SUBJECT: Reactor Coolant System Flow Measurement Uncertainty for SNUPPS

STATUS OF TECHNICAL SPECIFICATION OPEN ISSUES

PROPOSED TECHNICAL SPECIFICATION  
CHANGES AND JUSTIFICATIONS

FIGURE 3.2-3 RCS TOTAL FLOW RATE VS. R  
CALLAWAY FOUR-LOOP OPERATION

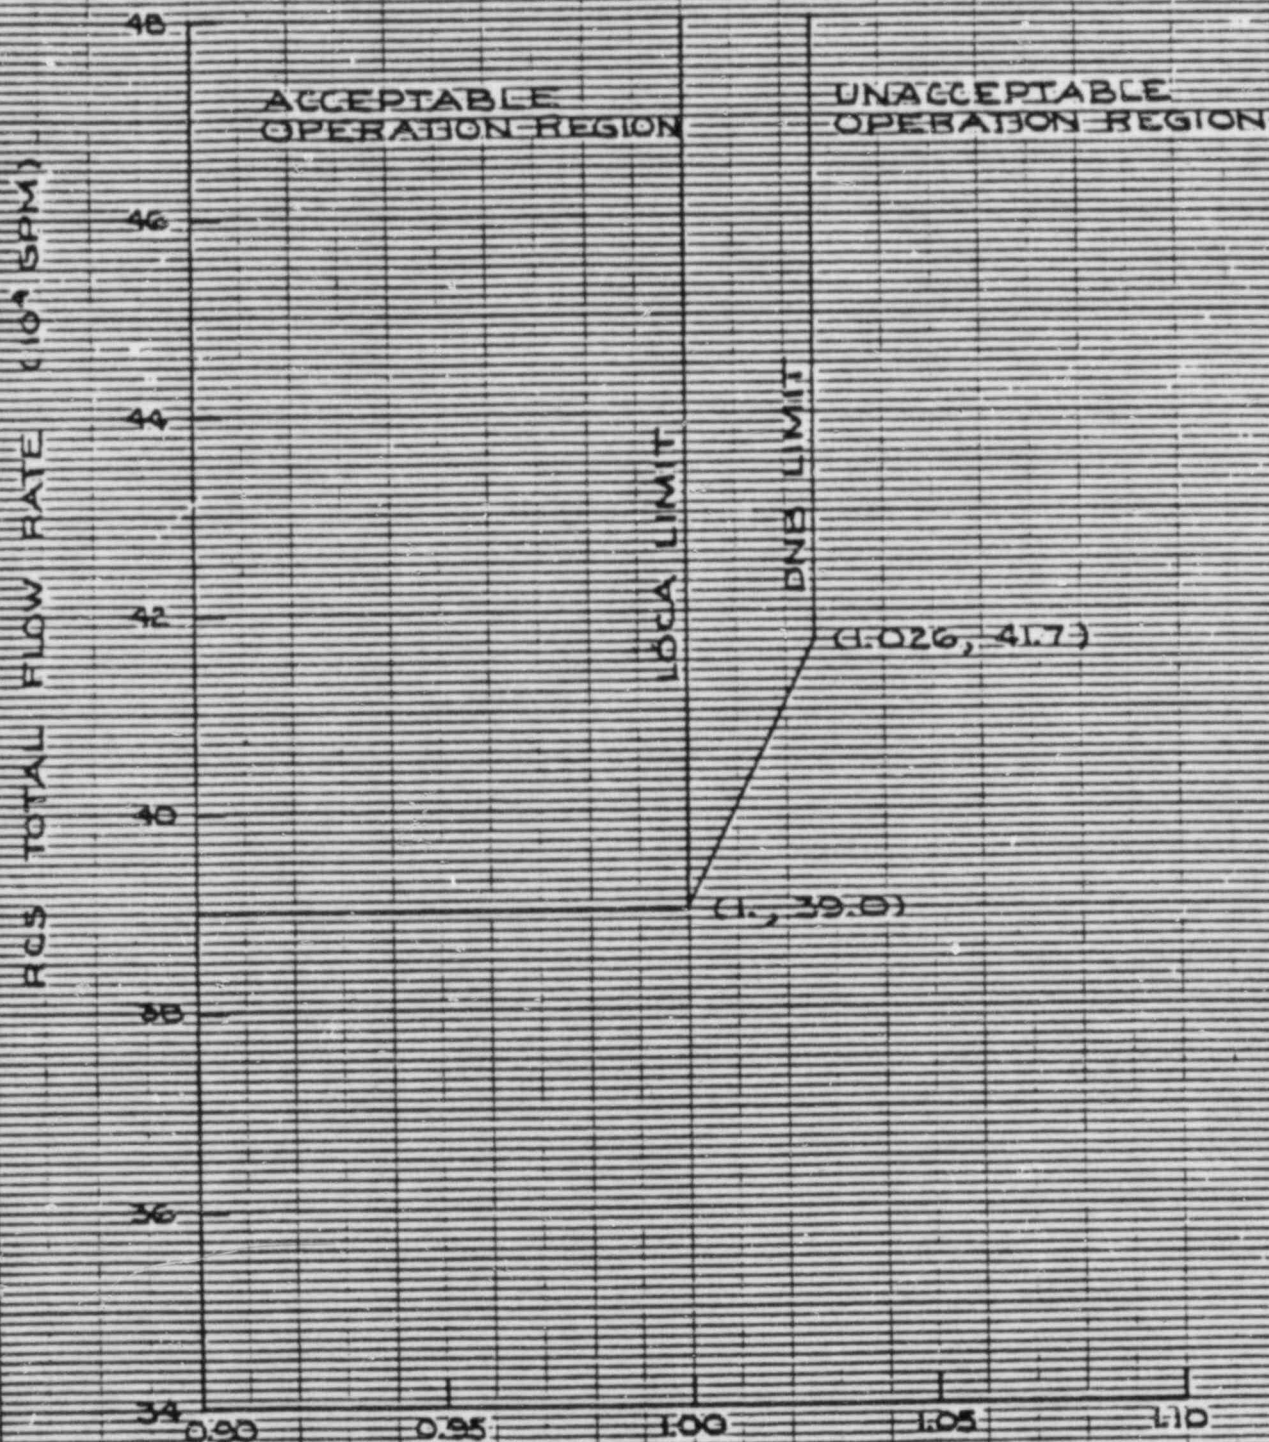
c.  $F_{\Delta H}^N$  = Measured values of  $F_{\Delta H}^N$  obtained by using the movable incore detectors to obtain a power distribution map. The measured values of  $F_{\Delta H}^N$  shall be used to calculate R since Figure 3.2-3 includes penalties for ~~undetected feedwater venturi fouling of 0.1% and for measurement uncertainties of 2.0% for flow and 4% for incore measurement of~~  $F_{\Delta H}^N$

- 4.2.3.4 The RCS loop flow rate indicators shall be subjected to a CHANNEL CALIBRATION at least once per 18 months.
- 4.2.3.5 The RCS total flow rate shall be determined by precision heat balance measurement at least once per 18 months. Insert A, following page

The measurement error for RCS total flow rate is based upon performing a precision heat balance and using the result to calibrate the RCS flow rate indicators. Potential fouling of the feedwater venturi which might not be detected could bias the result from the precision heat balance in a non-conservative manner. Therefore, ~~a penalty of 0.1% for undetected fouling of the feedwater venturi is included in Figure 3.2-3. Any fouling which might bias the RCS flow rate measurement greater than 0.1% can be detected by monitoring and trending various plant performance parameters. If detected, action shall be taken before performing subsequent precision heat balance measurements, i.e., either the effect of the fouling shall be quantified and compensated for in the RCS flow rate measurement or the venturi shall be cleaned to eliminate the fouling.~~ <sup>an inspection</sup> ~~is performed~~

- 4.2.3.5 (cont) Within seven days prior to performing the precision heat balance, the instrumentation used for determination of steam pressure, feedwater pressure, feedwater temperature, and feedwater venturi delta P in the calorimetric calculations, shall be calibrated.

- 4.2.3.6 The feedwater venturi shall be inspected for fouling and cleaned as necessary at least once per 18 months.

The instrumentation used in the performance of the calorimetric for the precision flow balance shall be calibrated within 7 days of performing the calorimetric.

FIGURE 6.2-2  
UNIT ORGANIZATION

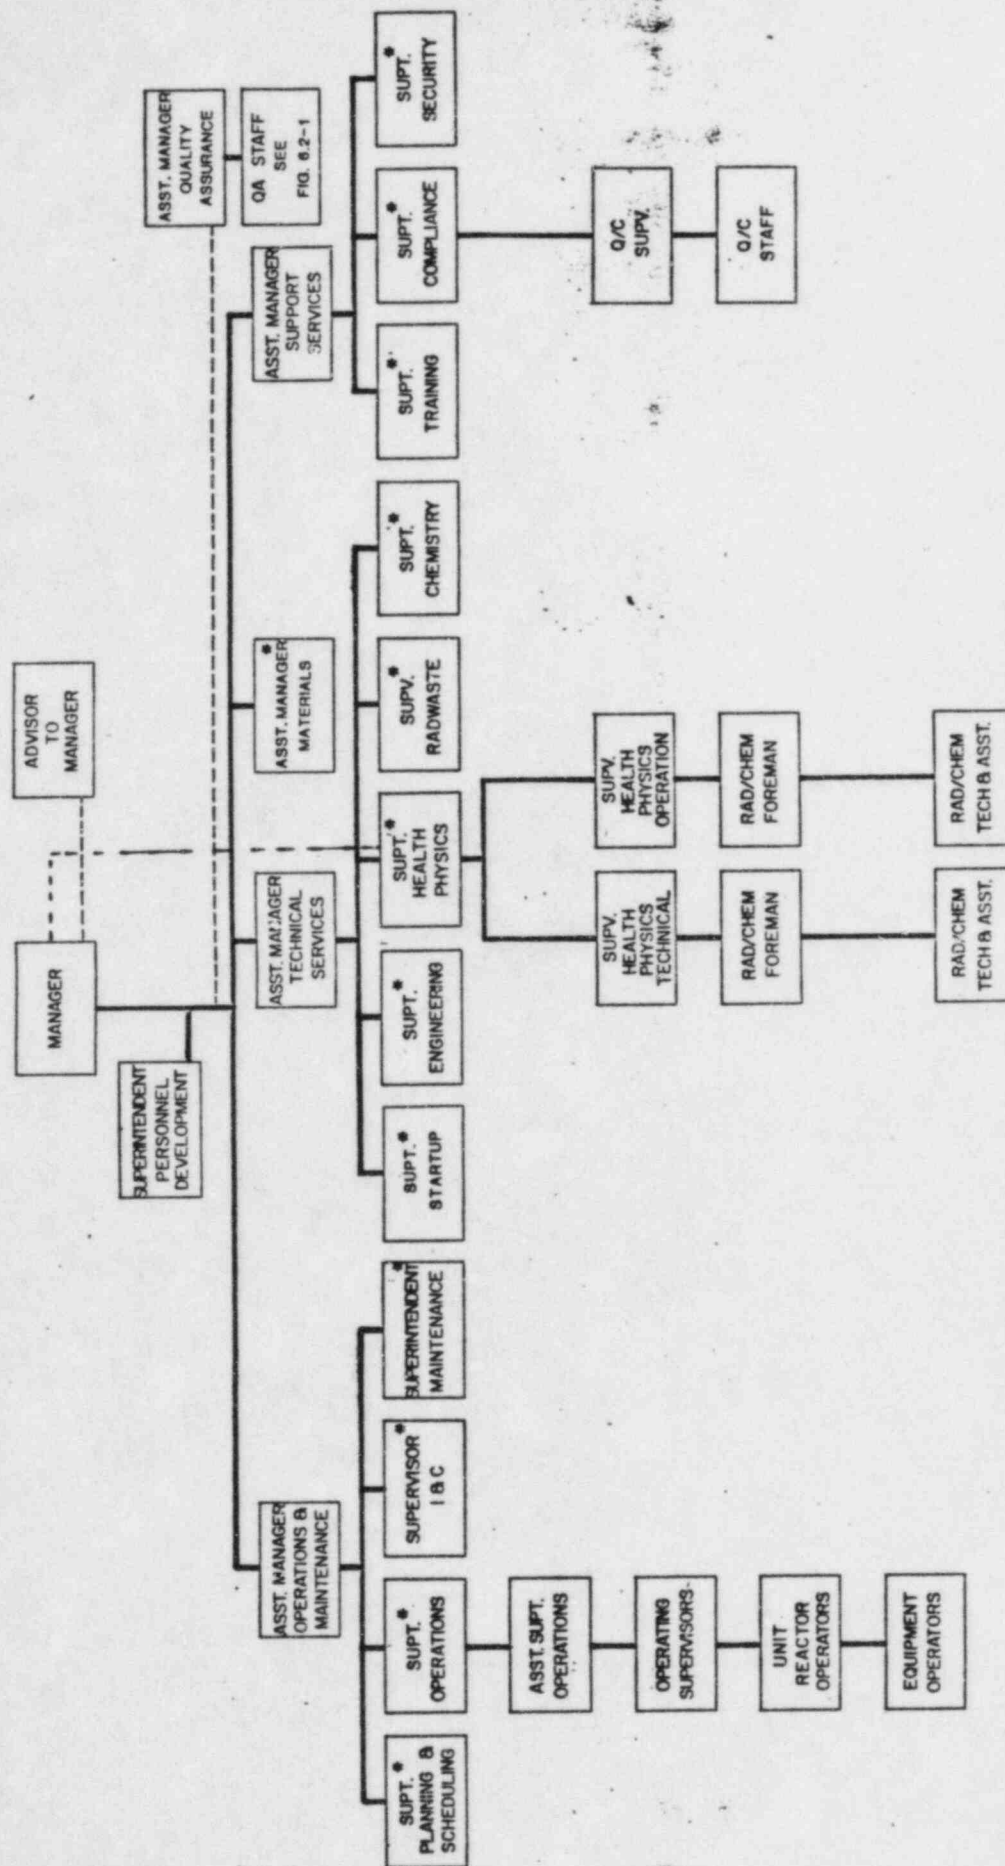
4.8.1.1.3	Diesel Generator Voltage Requirements	Expand allowable voltage range.	Included in Attachment 2
Tab 3.8-1	Containment Penetration Conductor Overcurrent Protection Devices	Correct table values for 13.8 kV switchgear.	Included in Attachment 2
Fig 6.2-1 Fig 6.2-2	Organizational Charts	Provide up-to-date versions of the organizational charts for Callaway.	Included in Attachment 2

FIGURE 1  
RCS FLOW CALORIMETRIC SCHEMATIC

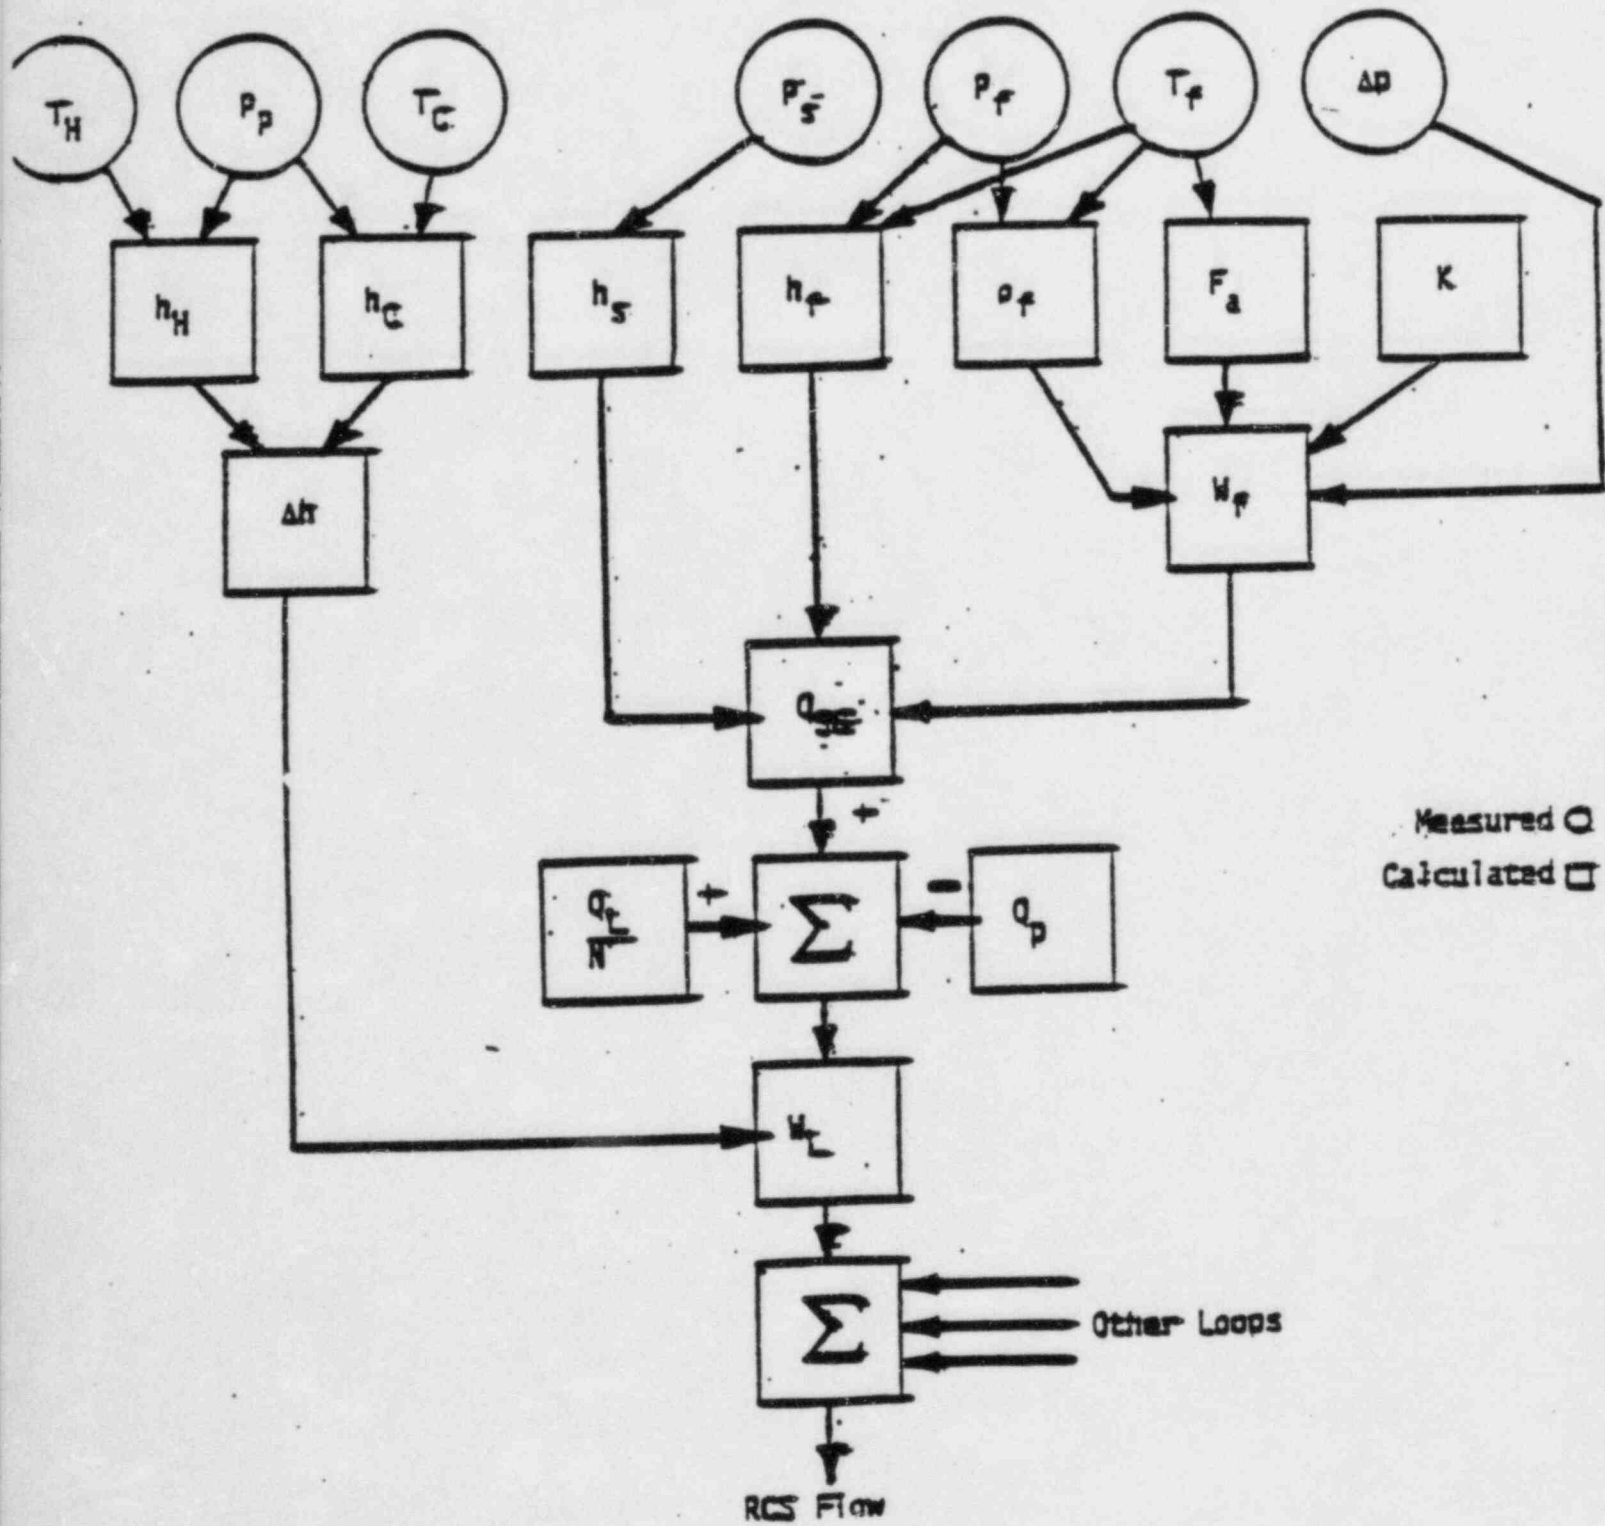
These measurements and calculations are presented schematically on Figure 1.
